HISTORIC AND DESIGN REVIEW COMMISSION

October 19, 2022

HDRC CASE NO: 2022-520
ADDRESS: 424 CLUB DR
LEGAL DESCRIPTION: NCB 7013 BLK LOT W 60 FT OF 4
ZONING: RM-4, H
CITY COUNCIL DIST.: 7
DISTRICT: Monticello Park Historic District
APPLICANT: Mark Ramirez
OWNER: TRIO INVESTMENT PARTNERS LLC
TYPE OF WORK: window replacement and fenestration changes, construction of a rear two-story deck
APPLICATION RECEIVED: September 23, 2022
60-DAY REVIEW: Not applicable due to City Council Emergency Orders
CASE MANAGER: Jessica Anderson
REQUEST:

AN ADDITION AT
424 CLUB DR.
MONTICELLO PARK
SAN ANTONIO, TX

These drawings are incomplete and may not be used for regulatory approval, permit or construction. For review only.

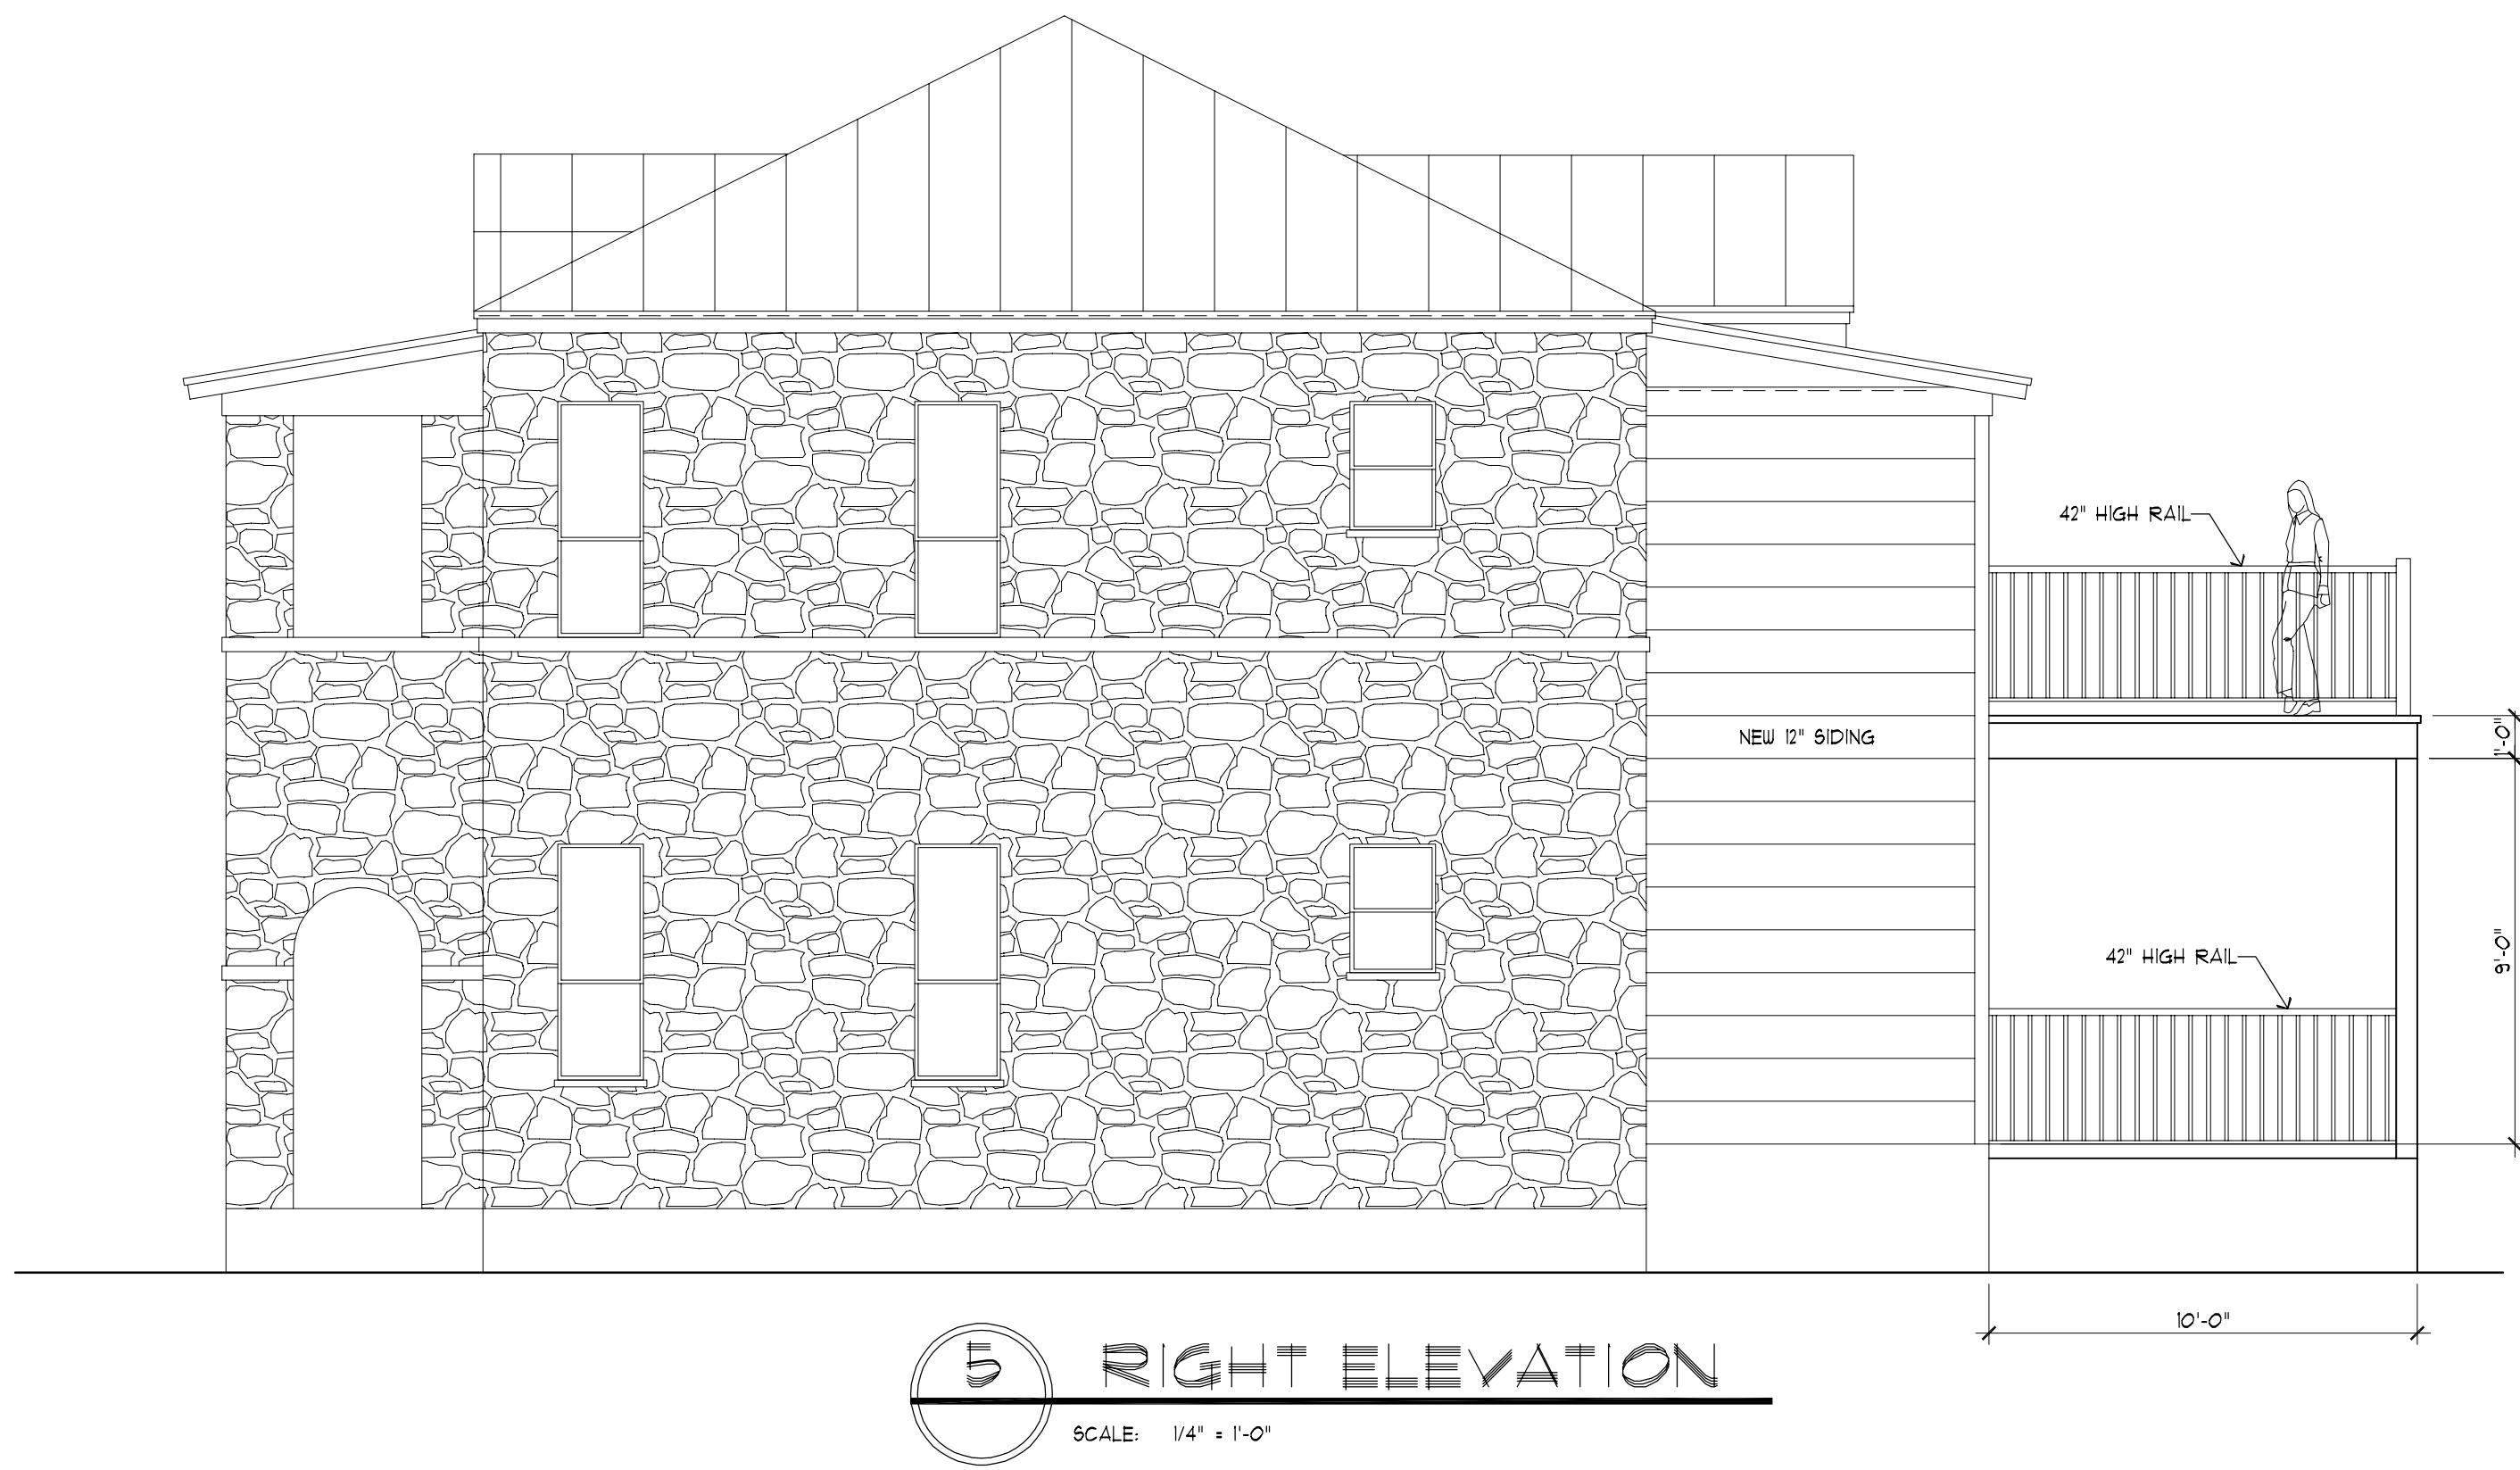
- e. **ADDITION: REAR PORCH:** The applicant requests approval to construct a two-story rear porch and to restore a door at the east end of the second floor of existing enclosed porch. Historic Design Guidelines for Exterior Maintenance and Alterations 7.B.v states that porches, balconies, and porte-cocheres should be reconstructed based on accurate evidence of the original, such as photographs. If no such evidence exists, the design should be based on the architectural style of the building and historic patterns. Staff finds the porch conforms to guidelines and that returning the second-floor door is appropriate. The applicant must ensure the new porch conforms to all setback guidelines as defined by UDC.

- f. **FENESTRATION CHANGES:** The applicant requests approval to remove one door from the primary elevation and replace it with a one-over-one window. Historic Design Guidelines for Exterior Maintenance and Alterations 6.A.i and ii state that historic doors and windows should be preserved. Staff finds the proposed door removal does not conform to guidelines.

Staff recommends approval of item 3, construction of a two-story rear porch and return of the rear second-floor door, based on finding e, with the following stipulation:

- i. That the applicant meet all setback requires as defined by UDC.

Staff does not recommend approval of item 4, replacement of one front door with a window, based on finding f.
